**UNITED STATES DEPARTMENT OF COMMERCE  
Patent and Trademark Office**

08/902,331 07/29/97 GRUENENFELDER

## Office Action Summary

## **DETAILED ACTION**

Page 9

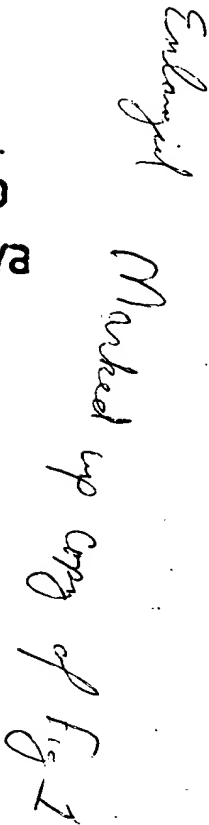
Furthermore Applicant indicates an equation wherein  $d_0 = d_{113} - a$  as shown in Fig. 1. Analysis of Fig. 1 does not show this relationship. First there is no clear disclosure of  $d_0$  in the drawing. Second and more notably, examination of the figure may not show this relationship. It appears that the upper surface of the target and lower limit of distance  $a$  are separated by a gap or

structure between the two components. The specification does not clearly set forth that the lower limit of distance  $a$  is directly adjacent to the upper surface of the target and Fig. 1, relied upon for this equation appears to show that the two components are not directly adjacent each other.

Therefore when determining the amount of taper the difference between  $d_{113}$  and  $a$  will give a value that is greater than  $d_0$  since it will also include the gap between the upper target surface and

a. For assistance in understanding the examiners position, an enlarged marked up copy of Fig. 1 is provided.

Appears that  
upper surface  
is not clear  
therefor  $d_o = d_{us} - a$   
not defined
